FILE NUMBER: Z190-158(RM) **DATE FILED:** December 6, 2019

LOCATION: Northeast corner of Gulden Lane and Singleton Boulevard

REQUEST: An application for a Planned Development District for office and mixed uses on property zoned an IR Industrial Research District.

STAFF RECOMMENDATION: Approval, subject to a revised development plan, a revised streetscape exhibit, and staff's recommended conditions.

APPLICANT'S PROPOSED DEVELOPMENT PLAN

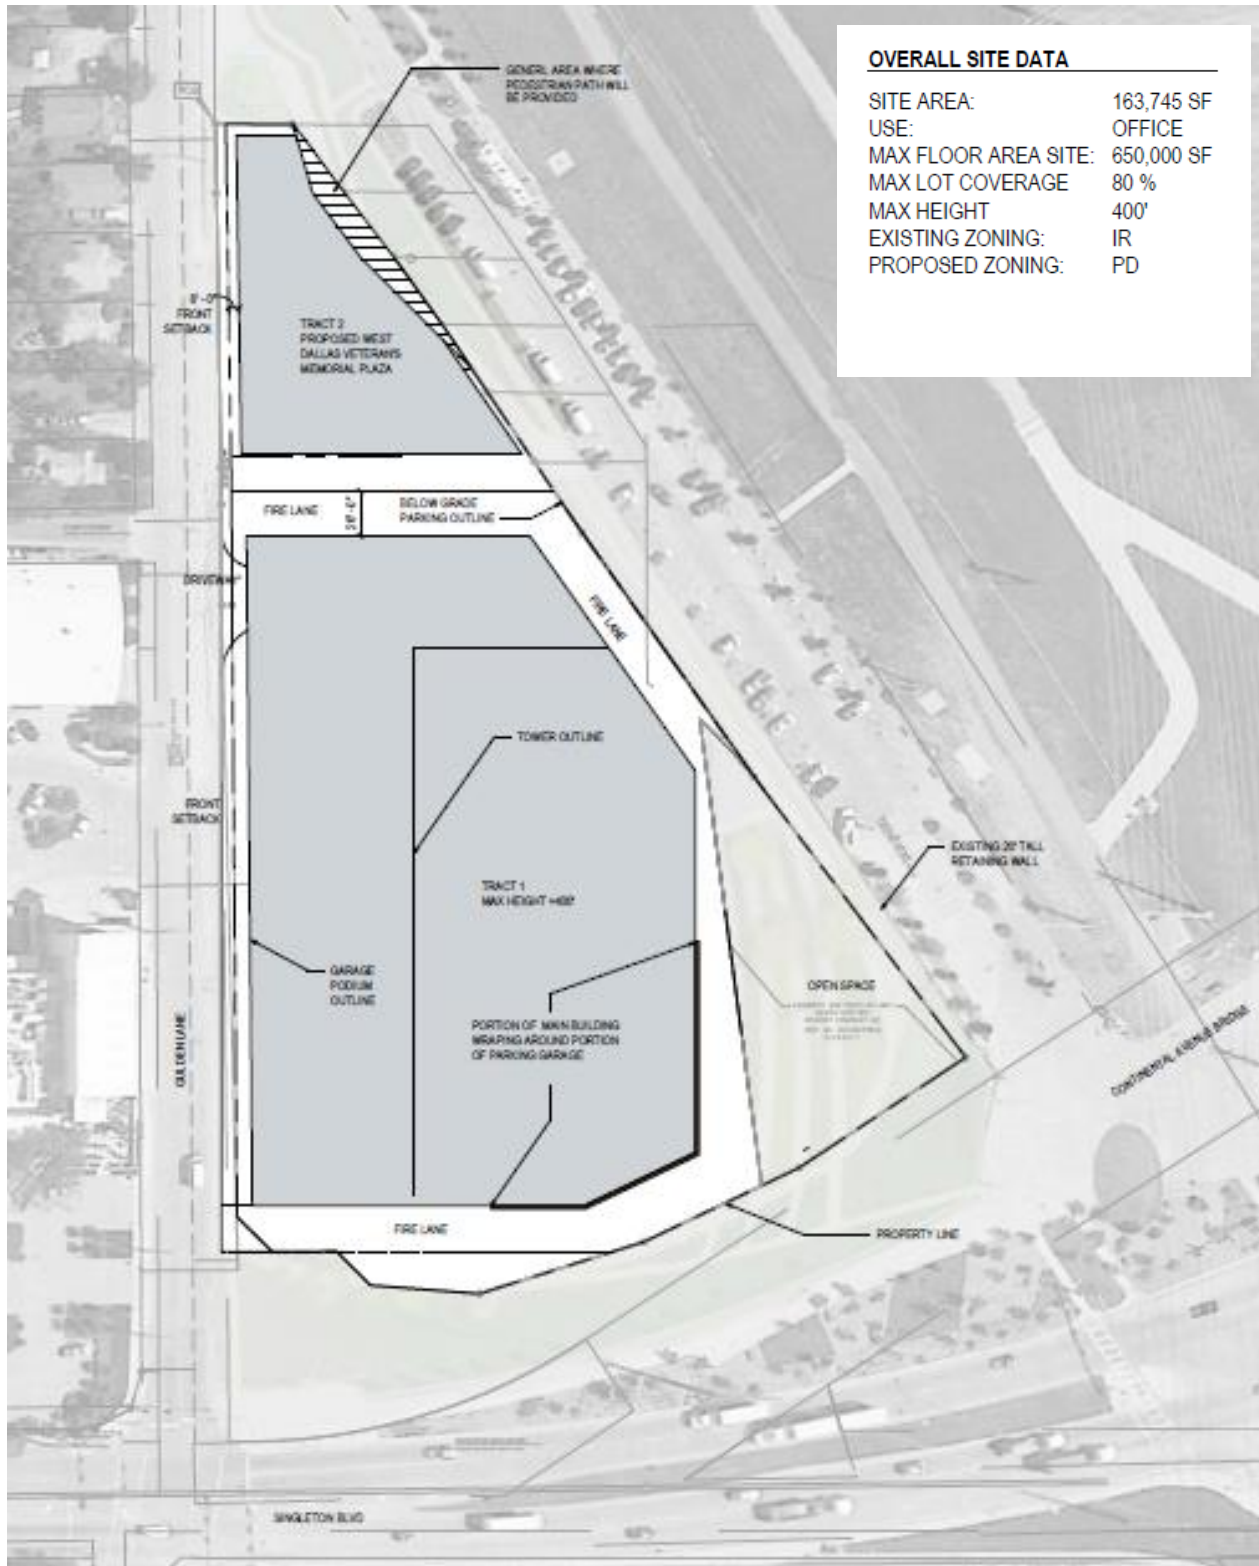
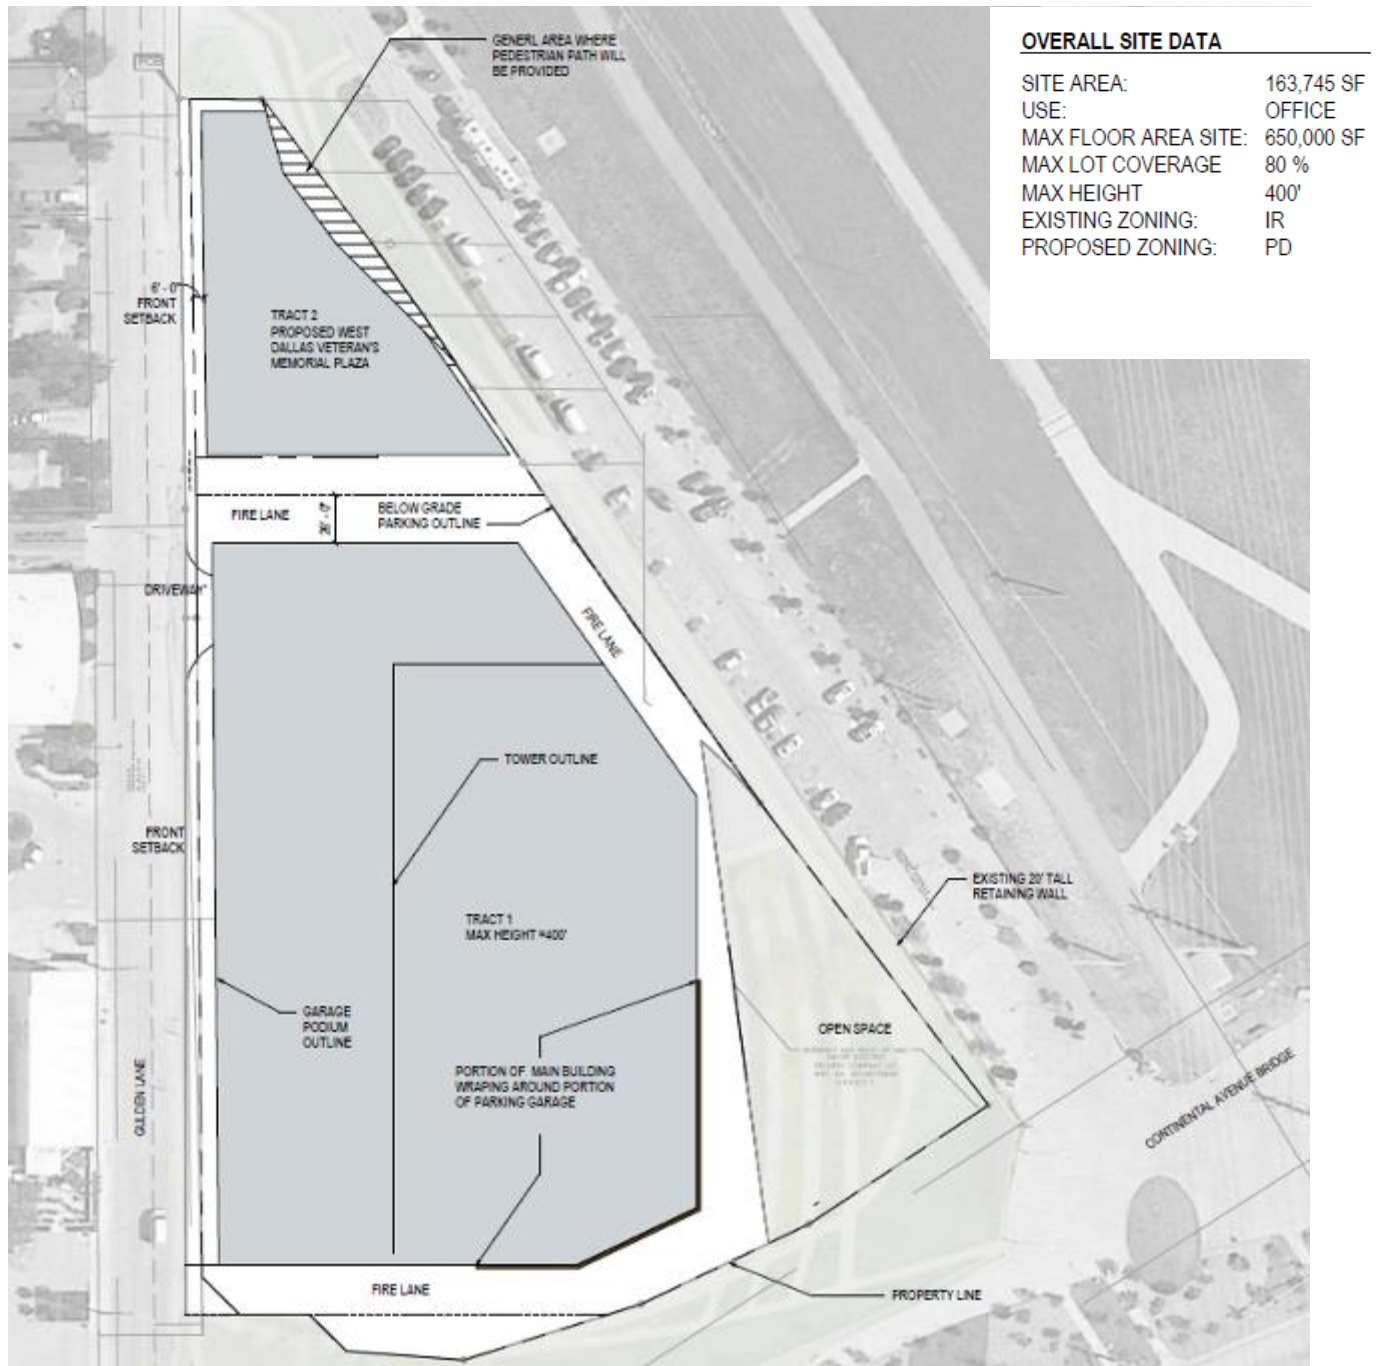
- 10) Allow shared improvements between Tract 1 and Tract 2 consisting of driveways, paved areas, fire lanes, and similar horizontal improvements.
- The proposed development plan has been revised to reflect a wider and longer pedestrian path, an open space area along the southeastern portion of the site, and the conditions have been revised removing the request for district identification signs and roof signs. The City Attorney Office, CAO has outlined concerns with roof tops signs, requested in PDs. As a result of the determination, rooftop signs are now limited to district identification signs, as an alternative. Staff does not support the inclusion of the open space due to the location along a major arterial road and the open space encroaching into a required 26-foot-wide fire land that encircles the development and prevents the open space from containing pedestrian amenities.

- As requested by the Commission, the development plan fails to provide an elevation for the office tower or garage podium and/or a varied height plan (like Z190-180) to better determine how the proposed height would be staggered with the maximum height moving east and away from the residential properties.

Staff does not support the request to allow surface parking on Tract 2. The request has received staff support due to the designation of Tract 2 being allowed only that of an open space or public amenity for the benefit of the community. Building Inspections has similar concerns with the lack of definition that can lend itself to subjective interpretation of “similar horizontal improvements.” While the conditions do not state the intention for surface parking, staff strongly believes that parking is the intention due to the added language of “similar horizontal improvements” that can only be interpreted as surface pavement. If the concern lies with utilizing a shared drive for access or a fire lane, BI has confirmed that the condition, is not needed and strongly discouraged, since a mutual access agreement can be submitted at permitting.

APPLICANT'S PROPOSED STREETSCAPE EXHIBIT

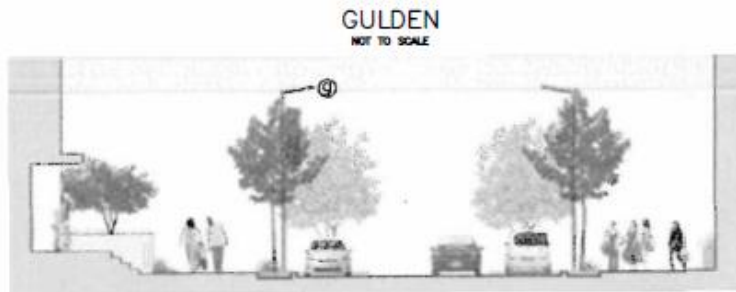
The Engineering Division of the Sustainable Development and Construction Department reviewed the request and finds that the deviation from the Complete Streets Manual regarding streetscape standards will not significantly impact the surrounding roadway system.
